Office Action Summary

10/524,185

HINSON ET AL.

DETAILED ACTION

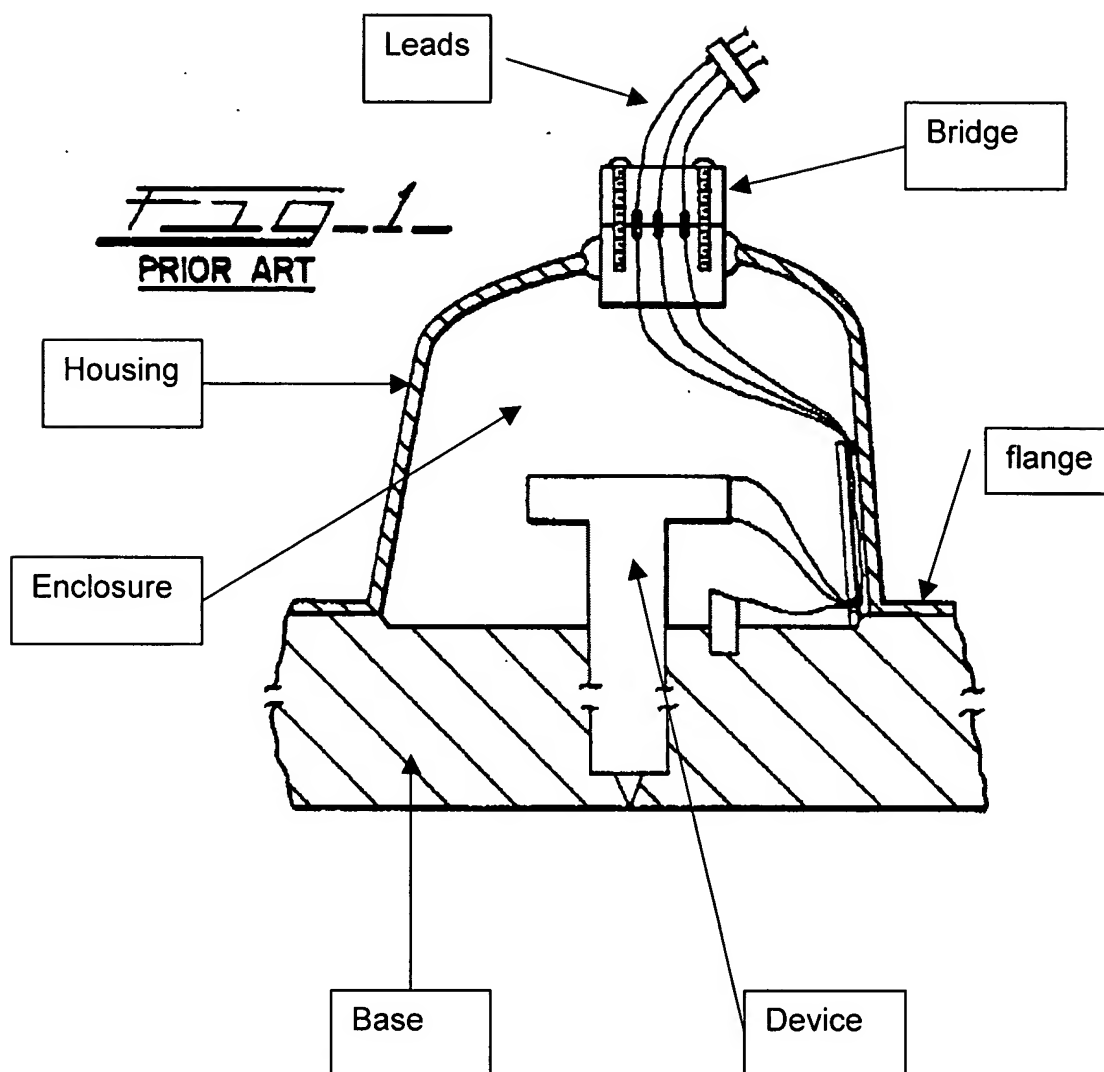
Regarding claims 1,3: Mathew discloses a cover with an electrical bridge comprising a base component; a housing mounted to the base component defining an enclosure therein; at least one electrical connector integrally formed with the housing, the at least one electrical connector including one or more electrical leads that extend through the housing for allowing electrical energy to pass from an electrical source

outside the housing to an electrical device within the enclosure, thereby forming an electrical bridge between the electrical source and the electrical device wherein "the electrical bridge does not extend along an exposed surface of the housing" (see labeled figure below).

Regarding claim 7: Mathew as modified above discloses the housing comprises a bottom "pan" flange (see labeled figure above).
